CITY OF FALLS CHURCH

Development Services Department Staff Report Addendum

SUBJECT: **SITE PLAN 20090057 - 6607 Wilson Boulevard, BJ's Wholesale Club**

DATE: March 27, 2009

BIOSWALE COMPUTATIONS AND DETAILS

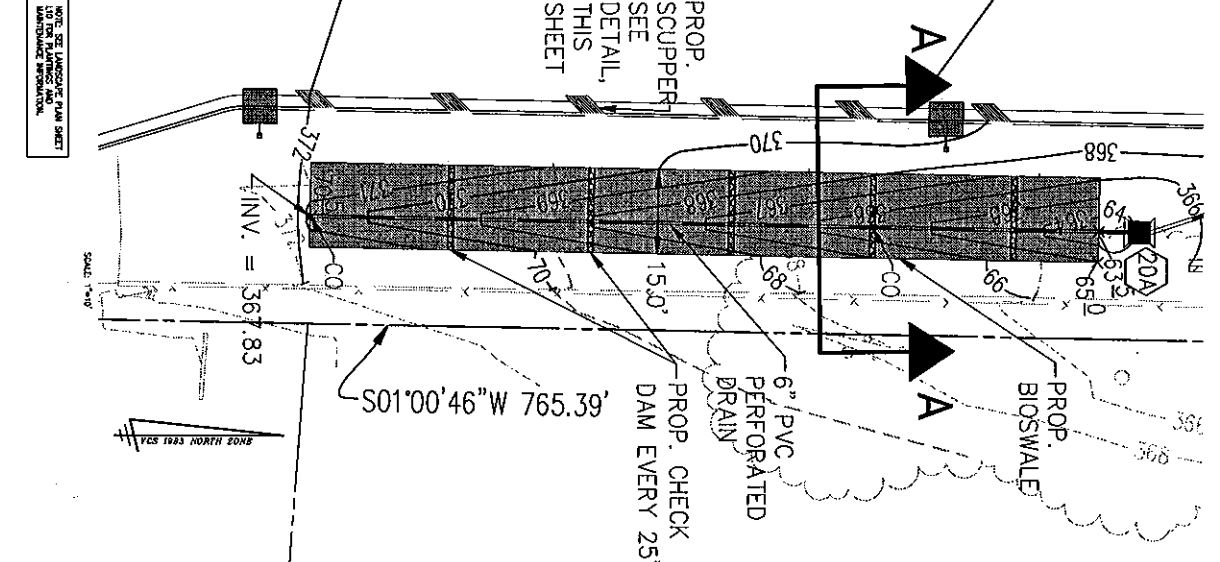
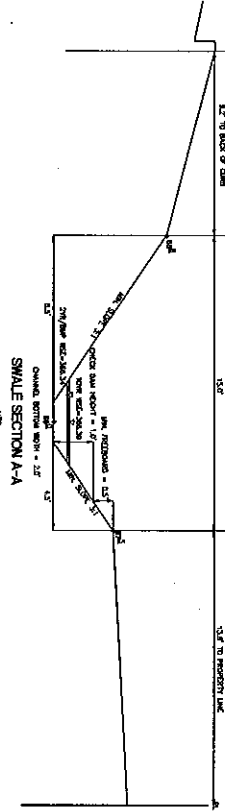
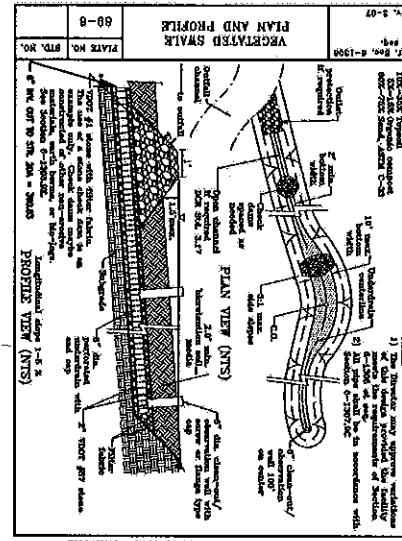
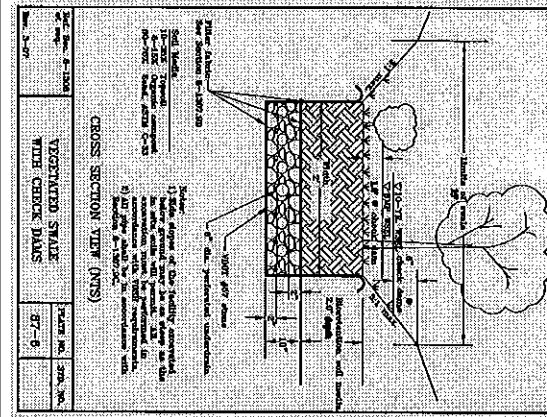
Since original submission, the applicant has worked to address the staff recommendation to install green elements on the site. The attached document (Attachment 1) is a newly planned bioretention swale that was submitted this morning and is currently under review by the City Engineer's office. Staff recommendation and appropriate site plan pages will be provided with the public hearing package.
